| Title | The Improvement of Scanning Method Using Preambles in IEEE 802.16e | |
| Re: | IEEE P802.16e/D3 Letter Ballot | |
| Purpose | The document is contributed to support certain comment on IEEE P802.16e/D3 Letter Ballot. | |

Figure E.1—Example BS advertisement and scanning (without association) by MSS request

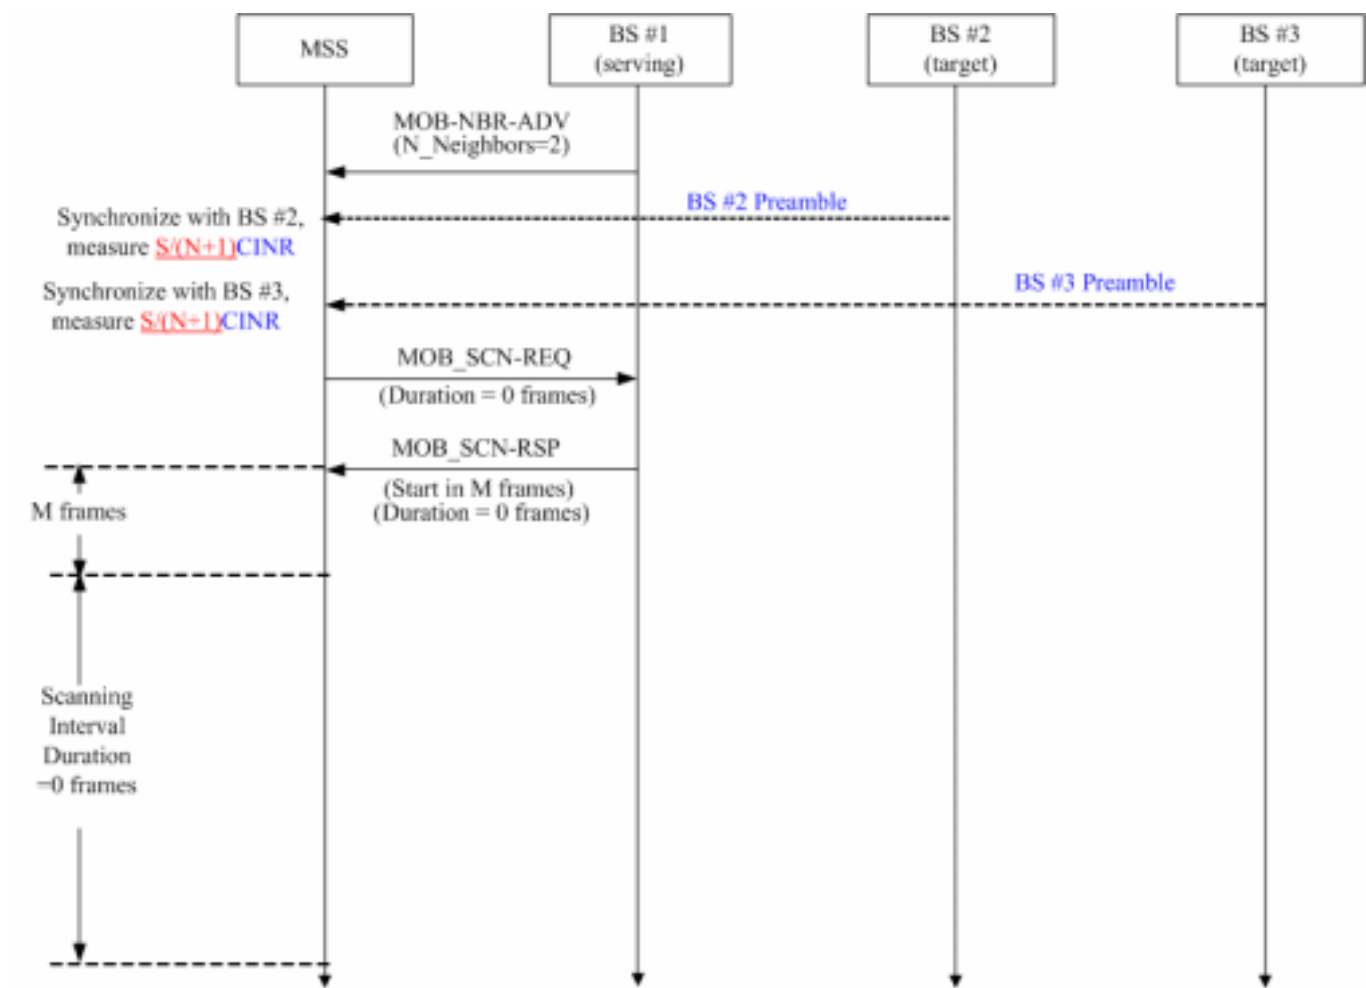
Currently, MSS performs synchronization and CINR measurement in scanning mode. As each MSS is able to receive the preambles from target BSs simultaneously, it can finish the synchronization and CINR measurement within a frame. In this process, MSS will decide the number of BSs that will be scanned and select the target BS for association. After that, MSS will receive RNG-RSP message from the target BS and transfer the time adjust information to the serving BS through the MOB-MSSHO-REQ message. The time adjust information will be used in selecting final target BS.

3. Proposed Text Changes
